Road Safety Audit of Pilot BRTS Corridor at Pune

Submitted to
Pune Municipal Corporation

Submitted by
Transportation Systems Engineering Group
Department of Civil Engineering
Indian Institute of Technology Bombay
Powai, Mumbai - 400 076

January 2014

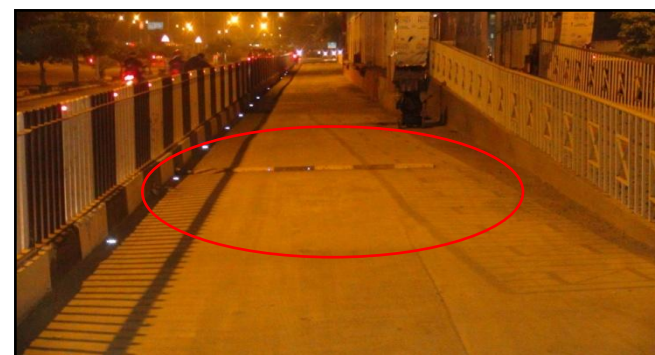
Observation 17: Rumble strip is placed on the bus lane without specific purpose. It will reduce the performance of BRTS (e.g. Ambedekar bus station). PMC officials explained that this is a temporary measure to habituate the BRT drivers

Night Time Audit: Corridor 1

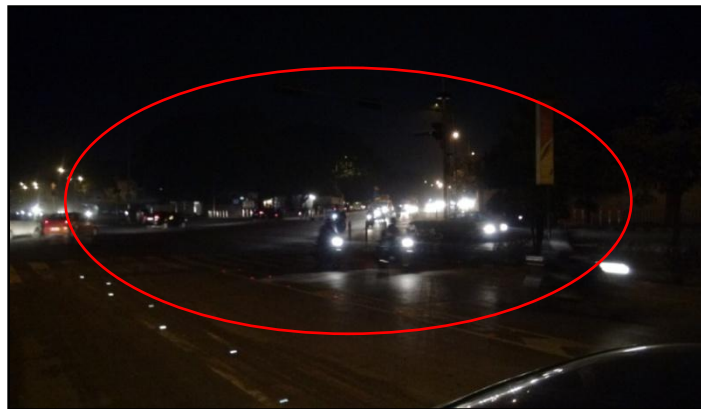
Observation 21: Insufficient lighting facility at Ambedkar society junction.

High mast lights at this location were not working which needs to be replaced.

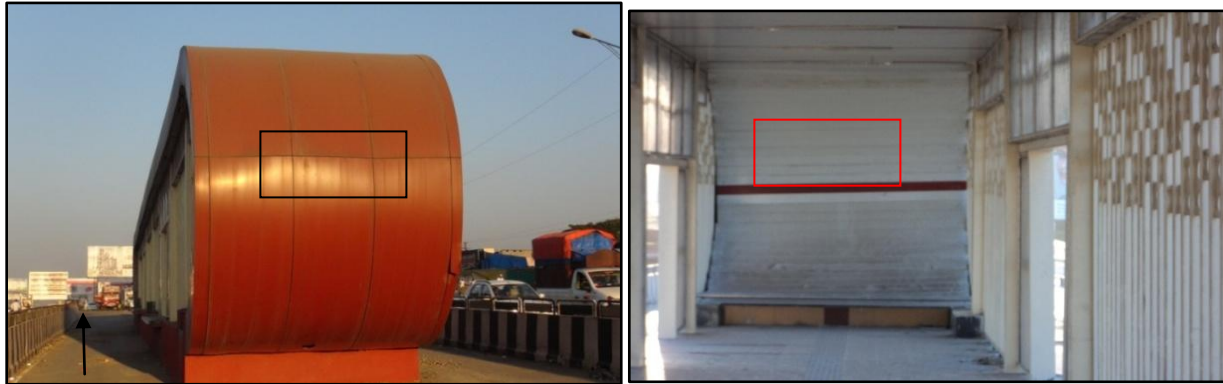
Observation 33: There is no possibility of getting information about bus arrival at bus stations (particularly non ramp side). Information system needs to be installed in each bus stations providing bus schedule details. Glass panel can be made to increase visibility of buses for users.

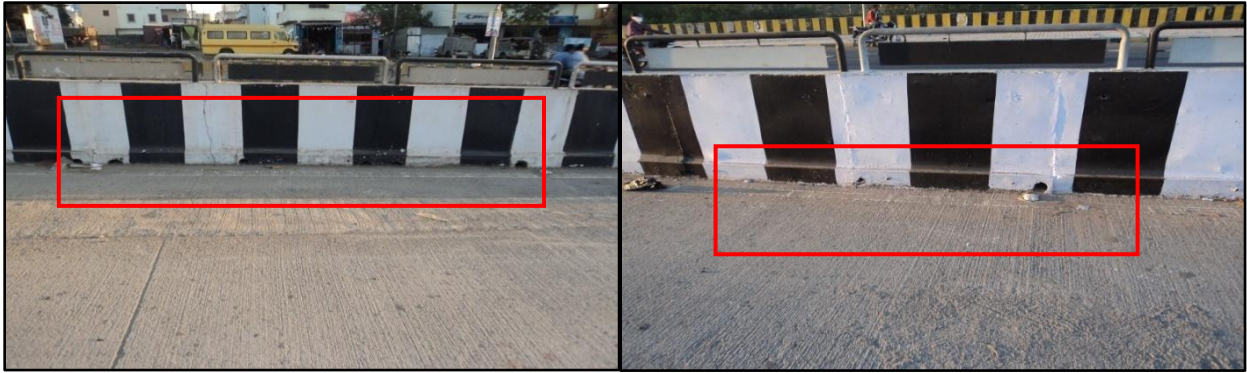
Observation 36: Temporary blockages of the drainage holes and cleaning needs to be done as this may result in possibility of water logging during rainy seasons.

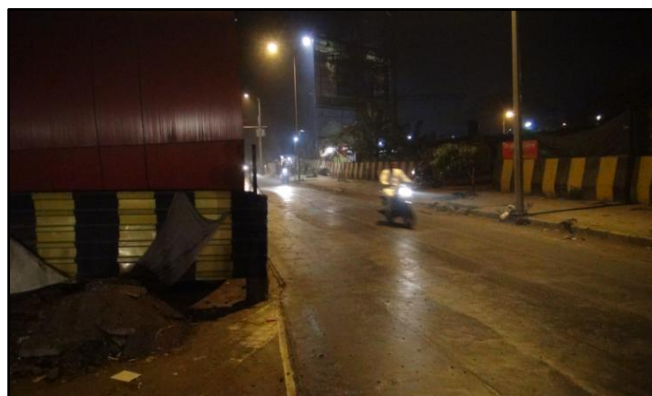
Observation 75: Road width is too narrow and is devoid of any information or warning sign board
